MODIFICATION TO CONNECT TO TOYOTA 8 WAY CONNECTOR

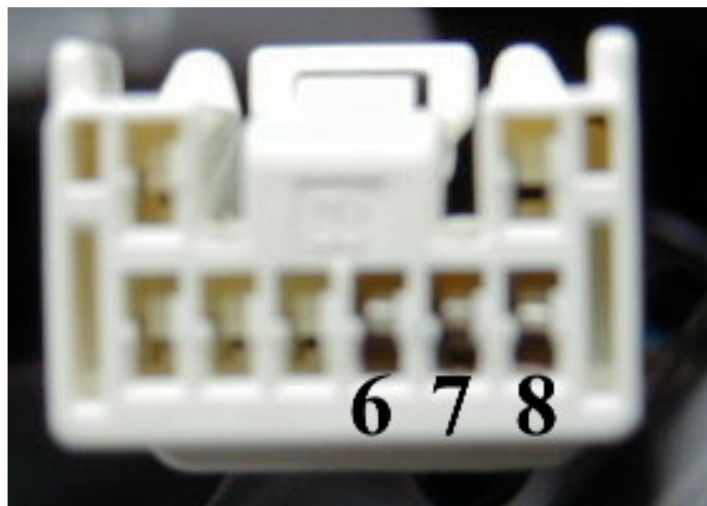
REMOVE WHITE 20 WAY CONNECTOR LEAVING BLACK, BLUE & VIOLET WIRES.

8 WAY SWRC IN VEHICLE.

**CONNECT BLACK WIRE TO PIN 6.
CONNECT BLUE WIRE TO PIN 7.
CONNECT VIOLET WIRE TO PIN 8.**
